VRC 2021-2022: Tipping Point

Etiquetado: R10

985: Plastic Limit

[R7-f from Nothing But Net Q&A 2](#) (this is R10 in the Tipping Point manual)

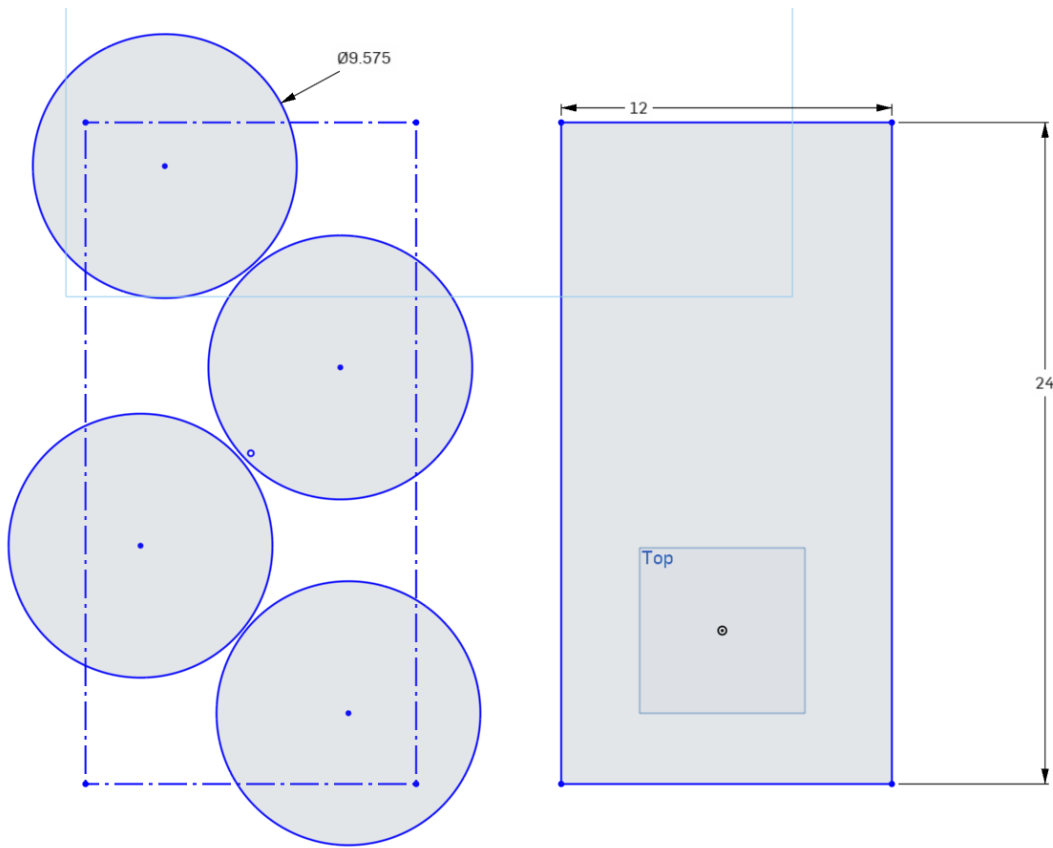
When using plastics, all pieces used must be able to be assembled into a sheet no longer than 12"x24". This is different than a maximum total area.

Attached are two images, both rectangles are 12"x24". The highlighted portions of both sheets are equal in surface area, but the left couldn't be reassembled into a 12"x24" sheet.

1. Is the plastic limit based on reassembling parts into a 12"x24" sheet, or is it based on total surface area?
 - a) If it's based on surface area, how are holes within parts accounted for? Are holes/pocketing subtracted from the total surface area of the part?
 - b) How should competitors prove the surface area of complex parts to inspectors and referees?

Thank you for bringing this to our attention and for attaching an example image. It turns out that "theoretically nesting into a single 12"x24" sheet" is *not* functionally the same as the total surface area exceeding 288 square inches. The answer to Q&A 975 has been updated, and R10 will be clarified further in a future Game Manual update.

1. Is the plastic limit based on reassembling parts into a 12"x24" sheet, or is it based on total surface area?

The former. However, the other portion of the answer from Q&A 975 is still correct - Teams are not required to literally use a single 12"x24" sheet of plastic.

The intent behind the requirement being "nest into a single sheet" instead of "288 square inches" is specifically to reduce complexity during inspection. In most cases, inspectors should be able to tell "at a glance" whether a given Robot is exceeding the permitted area (such as having four 9.5" diameter circles).

If a Robot is "pushing the limit", such as by having many small CNC'd parts that are nested perfectly to fit in a 12"x24" space, it would be within an inspector's authority to request a demonstration or documentation of the parts' legality. We would not expect this request to be an issue, for Teams who are abiding by the rule; generally speaking, a Team who is pushing the limit to this extent knows that they are doing so, and this type of detailed Robot design work is a perfect example of documentation that should be included in an Engineering Notebook anyways.

We are not going to mandate a specific form of documentation or proof; however, suggested examples could be CNC router drawings, BOMs that match labeled parts on the robot, or even a photo of all plastic parts disassembled and laid on a 12x24" area.
